# Seismic Hazard Reevaluation

June 30, 2014

# Objectives

- Discuss issues resulting from the NRC's review of BNP and RNP seismic hazard and screening reports
- Understand the reasons for the differences between the preliminary NRC and RNP GMRS
- Continue to support resolution of NRC questions and information needed for BNP and RNP

# Brunswick – Intake Canal

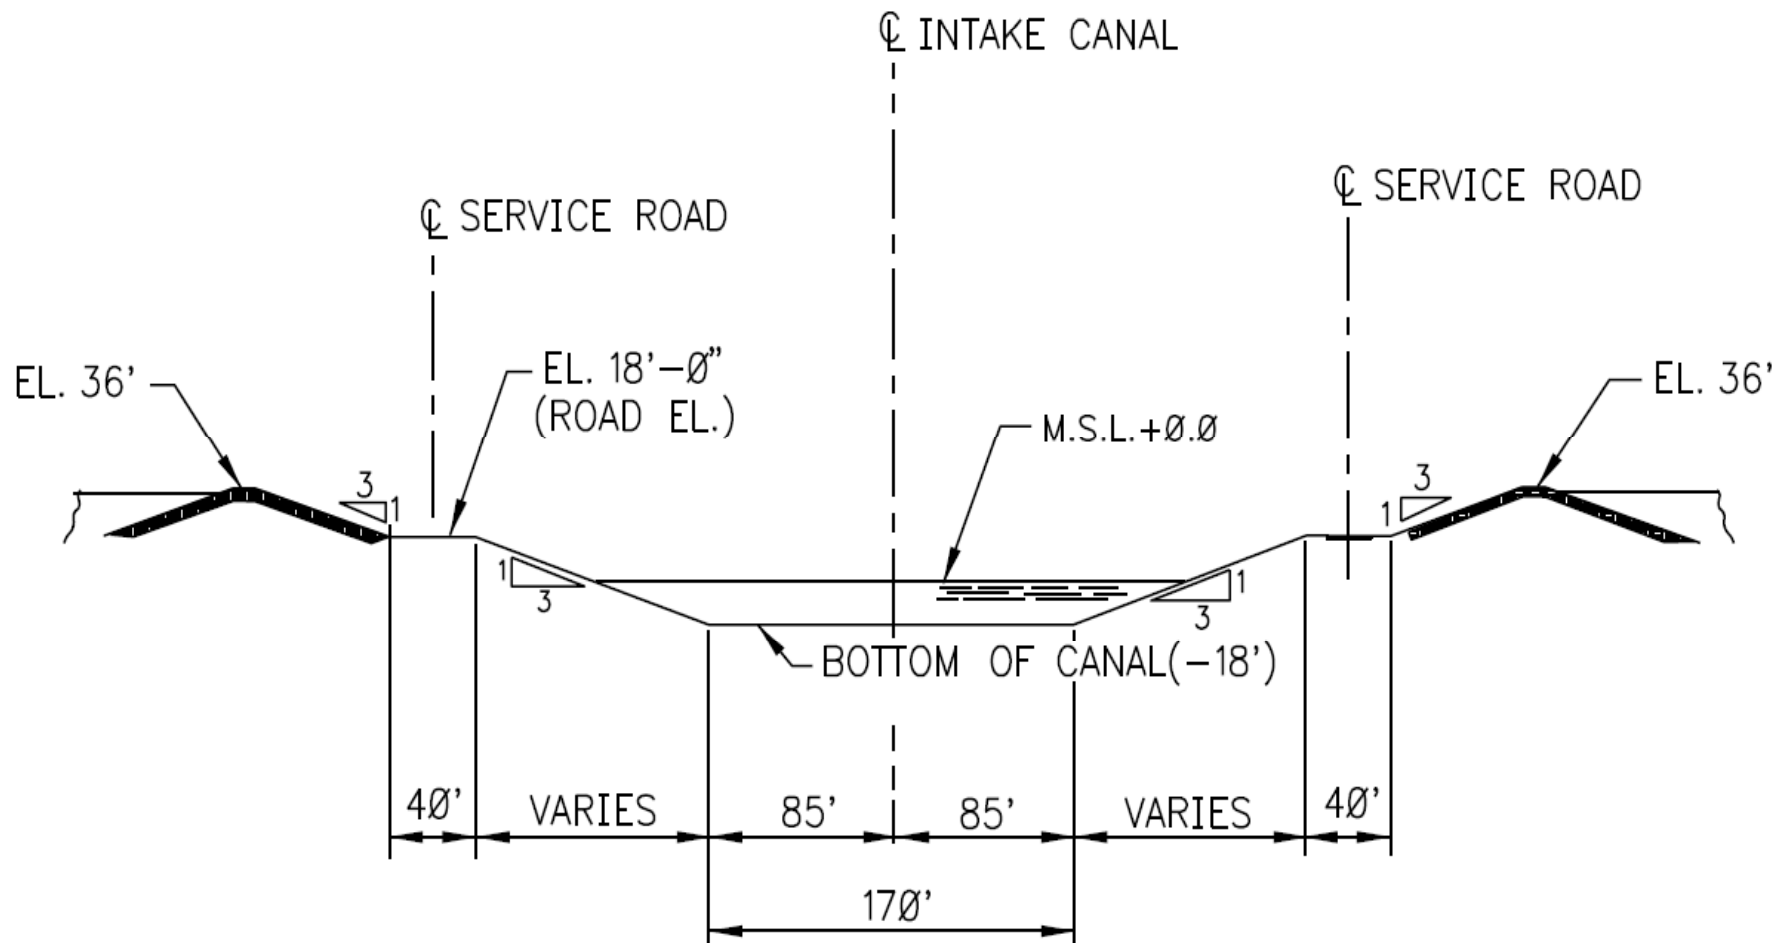
- NRC Question
  - Describe the basis for screening out slope stability along the Intake Canal under the review level earthquake loading
- Duke Energy Response
  - Original Intake Canal design evaluation acknowledged liquefaction and slope sliding
  - The total length of the Intake Canal is 2.57 miles
  - The bottom of the Intake Canal is at elevation -18 feet, the Intake Canal bottom is 170 feet wide, and the side slopes are at a 4H:1V slope in the marsh area, and 3H:1V in the high ground area
  - Intake Canal was originally designed to provide normal cooling water loads for five (5) units

- Duke Energy Response (cont.)
  - The Intake Canal is designed to accommodate a flow requirement of 1,390 cubic feet/second per unit
  - The maximum designed capacity of the Intake Canal is approximately 7,000 cubic feet/second
  - Intake Canal channel mean sea level (MSL) velocity for one unit operating is 0.3 feet/second (fps), and maximum low tide velocity is 0.4 fps. When two units are in operation the MSL velocity is 0.6 fps, and maximum low tide velocity is 0.8 fps
  - The maximum acceptable low water level Intake Canal velocity is limited to 1.5 fps

## GEOLOGIC COLUMN

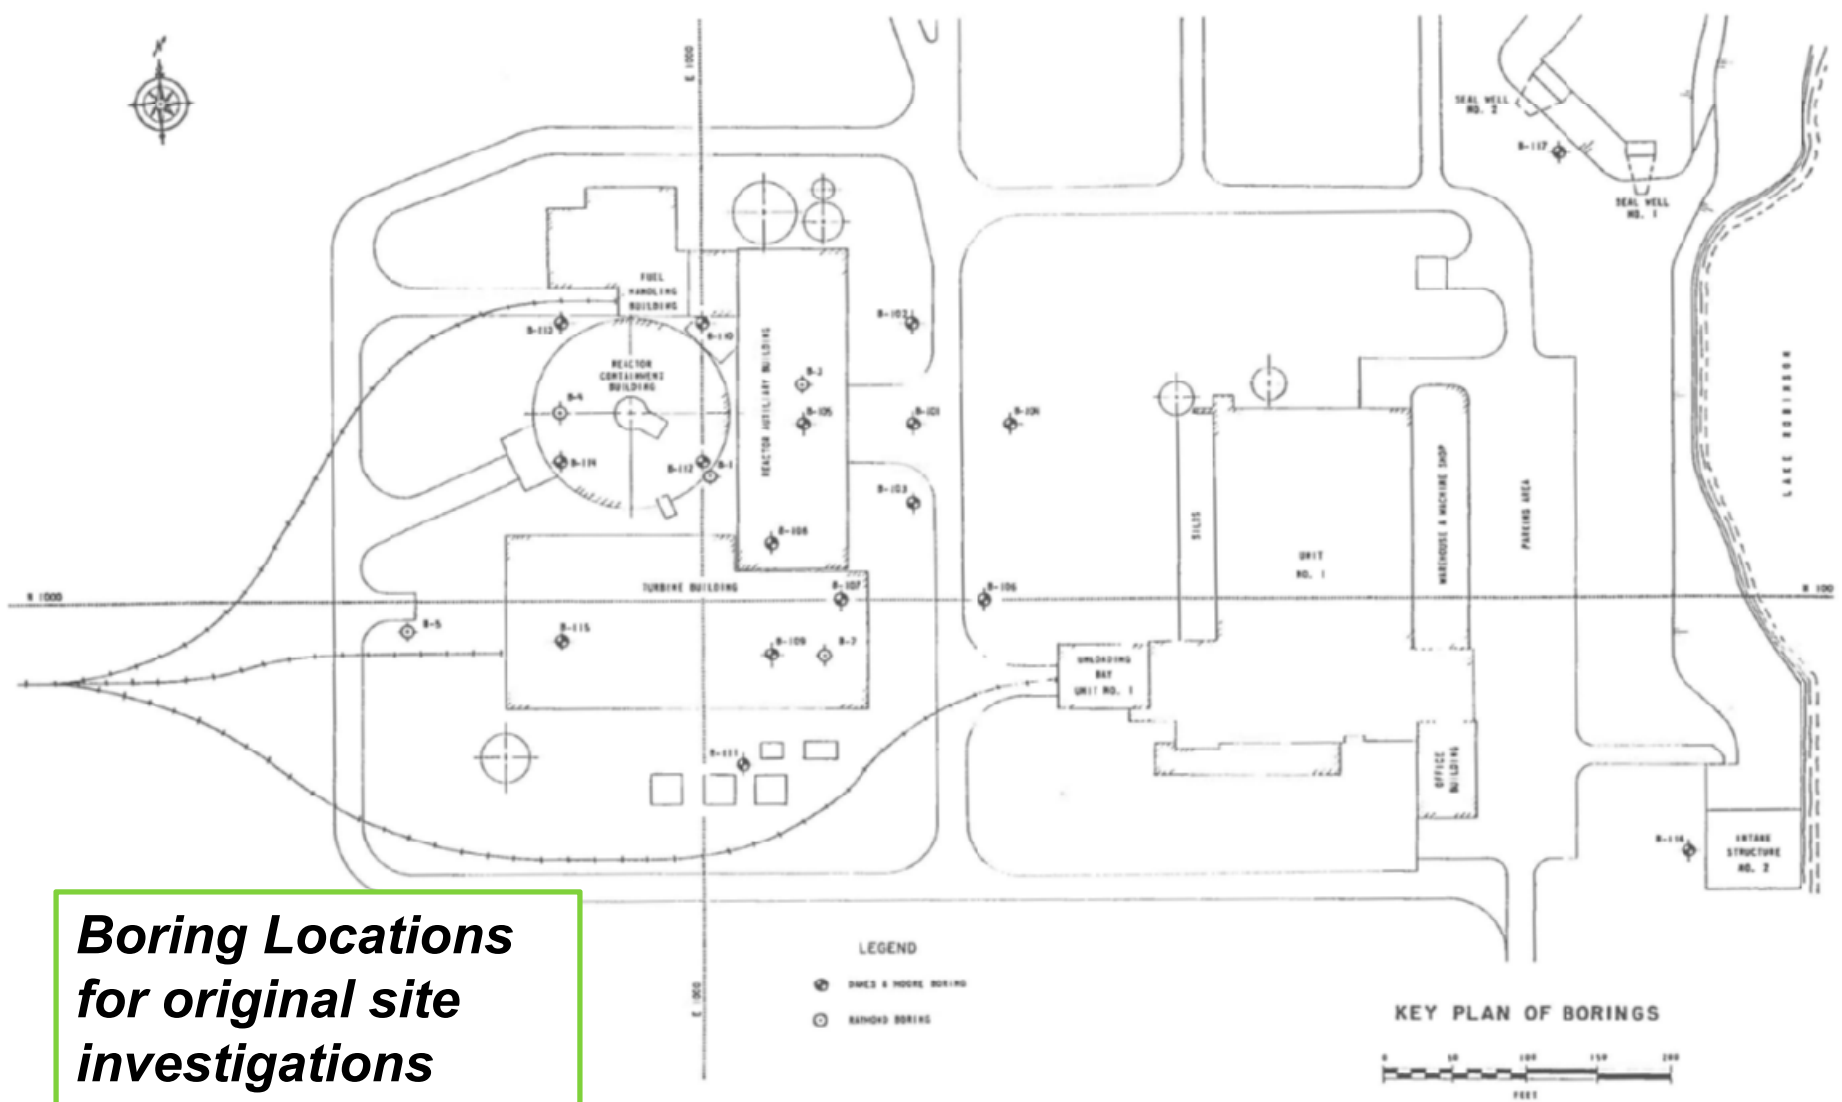
- NRC Topic 1
  - Thickness of alluvium at surface
- Duke Energy Response
  - For thickness of alluvium layer, NRC Staff used UFSAR Section 2.5.4.1 and UFSAR Figure 2.5.1-2
  - RNP also used data from UFSAR Section 2.5.4.1, UFSAR Figure 2.5.1-2, supplemented with recent site geologic profile site investigations for the Independent Spent Fuel Storage Installation (ISFSI)

- Duke Energy Response (cont.)
  - UFSAR Section 2.5.1.2, *“In general, the upper alluvial sands and gravels are moderately compact. Layers of compressible material occur in the upper 30 to 50 feet.”*
  - UFSAR Section 2.5.4.1, *“The piedmont crystalline basement rock at the site is overlain with approximately 460 feet of unconsolidated coastal plain sediment. These sediments are comprised of about 30 feet of surface alluvium over 430 feet of the Middendorf formation.”*

# GMRS - Robinson

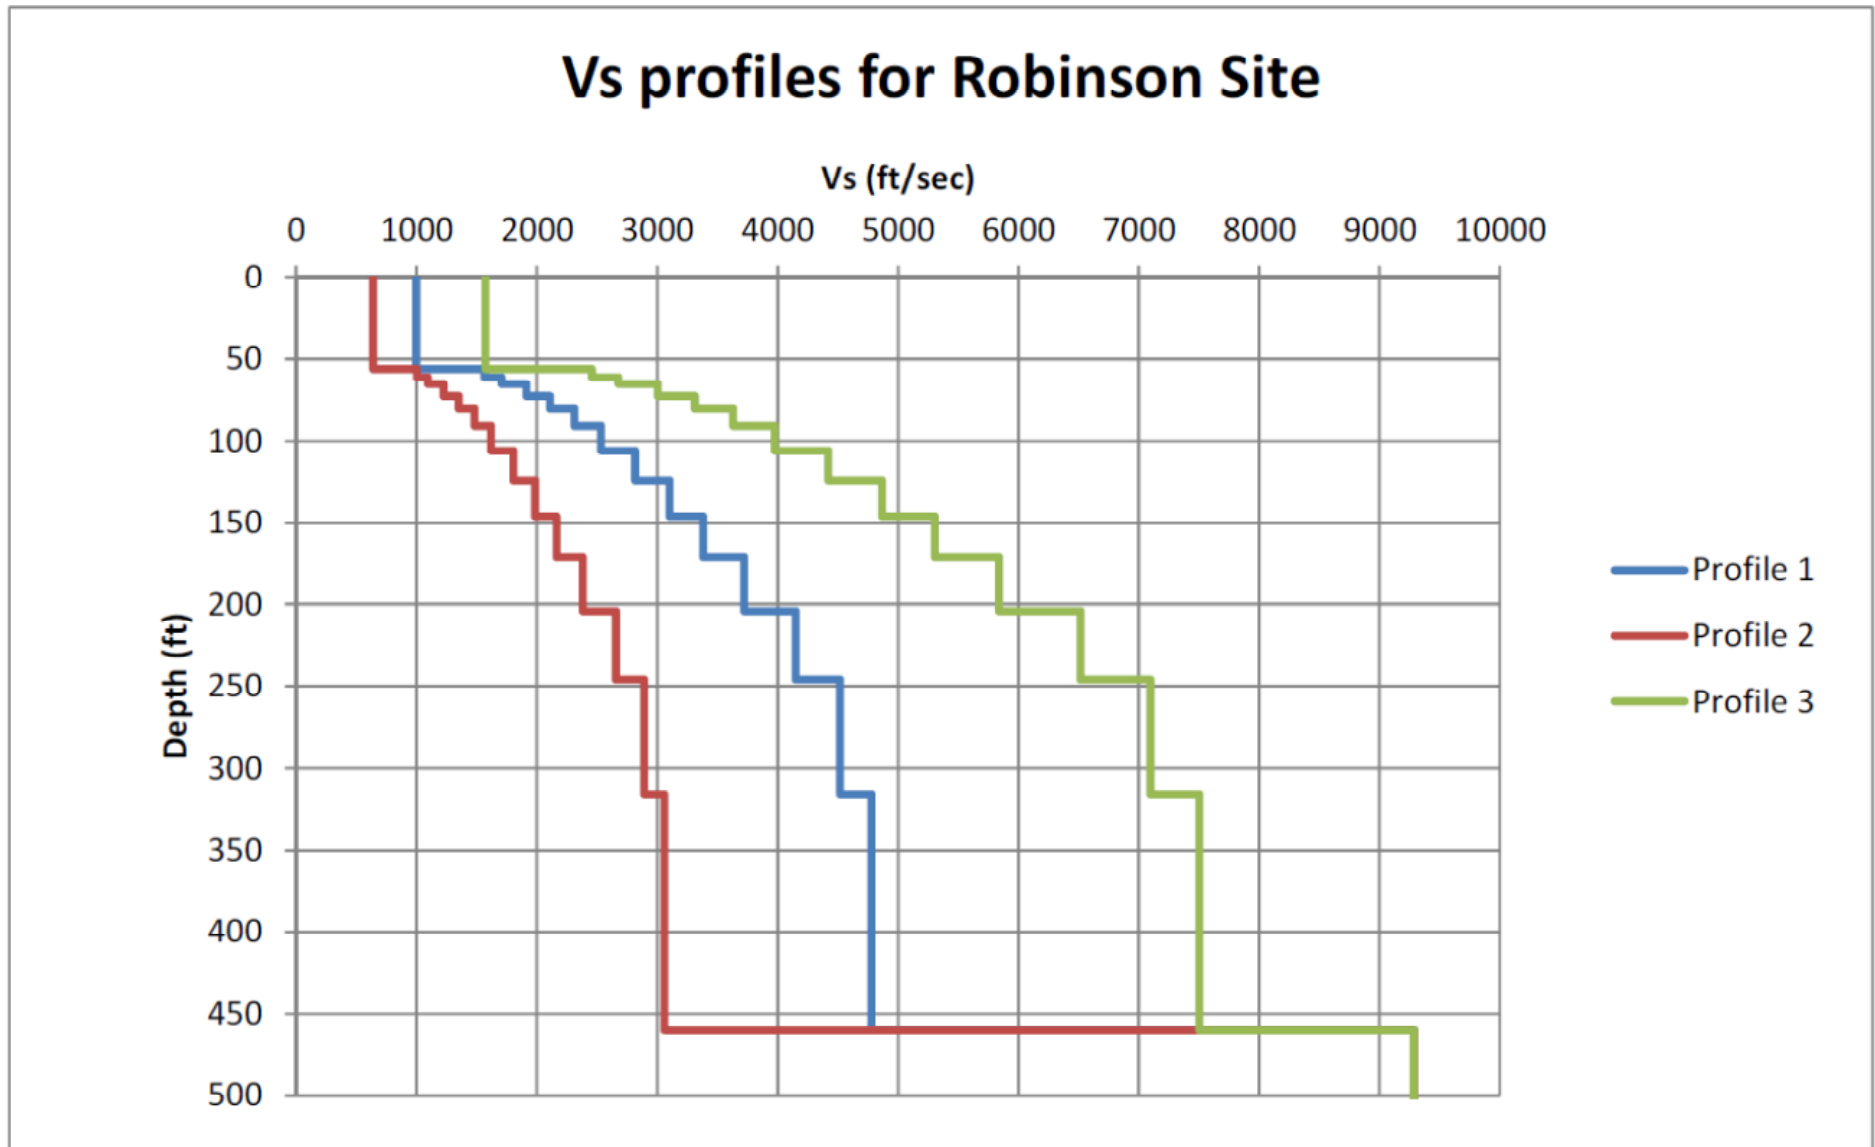
- NRC Topic 2
  - Shear-Wave Velocity profile for the Tuscaloosa Formation (Middendorf)
- Duke Energy Response
  - For Vs of Middendorf (Tuscaloosa) formation, NRC staff used USGS Open File Report 03-043 (Odum et. al., 2003)
  - RNP data from UFSAR Section 2.5.4.1, UFSAR Figure 2.5.1-2 based on Seismic Refraction survey Compression Wave Velocity ( $V_p$ ) and assumed Poisson ratio.
  - Applied Vs of 3,600 feet/sec as average over 404 feet

- Duke Energy Response (cont.)
  - Shear-Wave Velocity profile of 1,000 feet/sec for alluvium is based on testing associated with ISFSI soil exploration
  - Average Shear-Wave Velocity of 3,600 feet/sec is used for the Middendorf (Tuscaloosa) formation based on UFSAR Figure 2.5.1-2
  - Shear-Wave Velocity profile of 11,200 feet/sec for granite, gneiss, phyllite schist is based on UFSAR Figure 2.5.1-2
  - Following the SPID, the soft rock generic gradient was used for 404 feet of stiff soils and soft rock, 760 m/s Vs(30m) template
  - Adjusted to the average Vs over 404 feet of 3,600 feet/sec
  - A depth dependent velocity gradient is used to more accurately represent in-situ conditions
